# **IPC Briefing – Gateway Review**

**24, 26-30 Parkes & 114-116 Harris St, Harris Park**

# Parramatta CBD Planning proposal & subject site

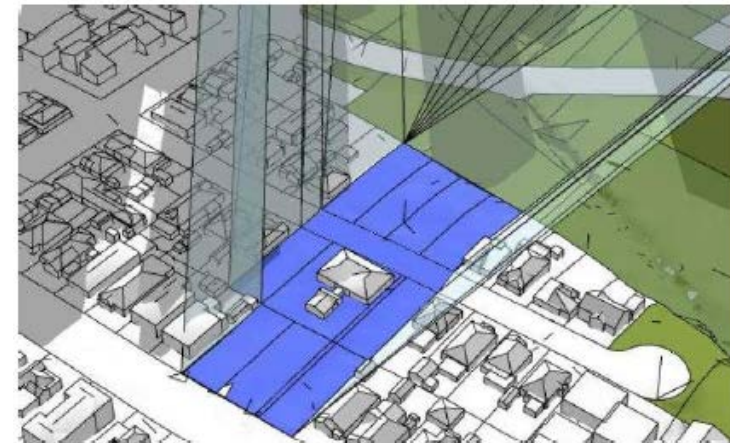
- PP seeks an exemption to the sliding scale, to enable the full maximum FSR proposed under the Parramatta CBD.
- The purpose of the sliding scale (Clause 7.2) is to ensure smaller sites have an appropriate FSR, to encourage site amalgamation and to avoid isolated sites.
- The Parramatta CBD PP sliding scale provision would enable a FSR ranging from 8.53:1 to 9.88: 1 for each of the individual sites subject to this PP, excluding any bonus.
- Parramatta CBD PP proposes to include exceptions for isolated lots, where certain criteria can be met.
